[Docket No. 2001-SW-40-AD; Amendment 39-12793; AD 2002-13-05]

Airworthiness Directives; MD Helicopters, Inc. Model 369D, 369E, 369F, and 369FF Helicopters

ACTION: Final rule.

Figure 1 - Inspection Location

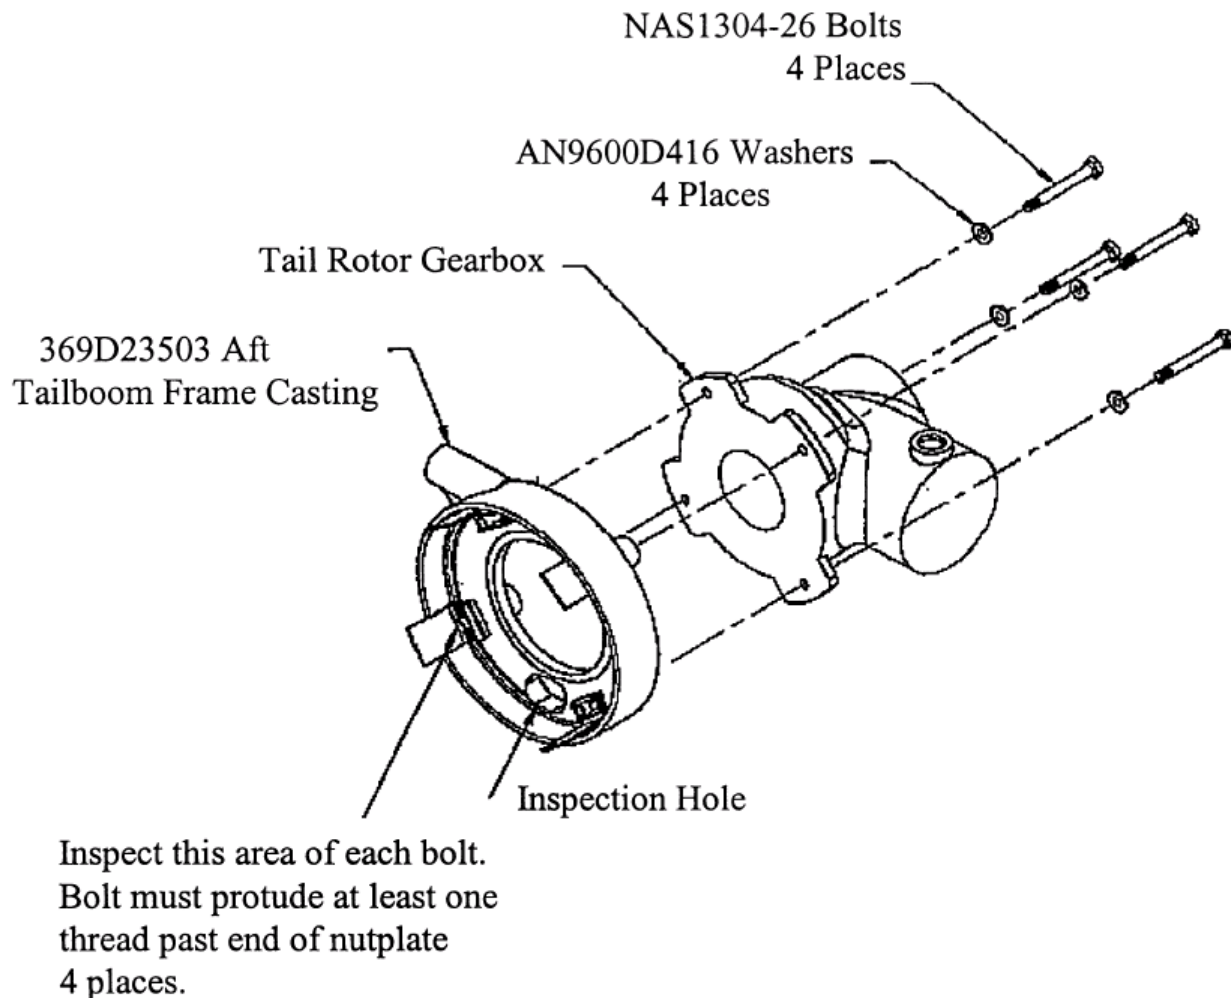
- (a) Within 25 hours time-in-service (TIS), conduct the following inspections:
 - (1) For each tail rotor gearbox attaching bolt (bolt):
 - (i) Determine the part number (P/N).
 - (ii) If the P/N cannot be determined or if the bolt is not P/N NAS1304-26, before further flight, replace the bolt with bolt, P/N NAS1304-26.
 - (iii) Torque the bolt to 100-110 in-lbs and apply a slippage mark.
 - (2) Remove the tailboom control rod and determine the number of bolt threads protruding from each nutplate on the internal surface of the aft tailboom frame casting, P/N 369D23503, as shown in Figure 1 of this AD. At least one thread must protrude. If more than four threads protrude, add an additional washer, P/N AN960D416, under the bolt head. Torque the bolt to 100-110 in-lbs, and reapply a slippage mark. See Figure 1:

(b) Between 2 and 10 hours TIS after accomplishing the requirements of paragraph (a) of this AD, inspect the torque on each bolt by applying 100 in-lbs. If any bolt movement occurs, retorquing the bolt to 100-110 in-lbs and reapply a slippage mark. Reinspect the torque between 2 and 10 hours TIS thereafter until no bolt movement occurs.
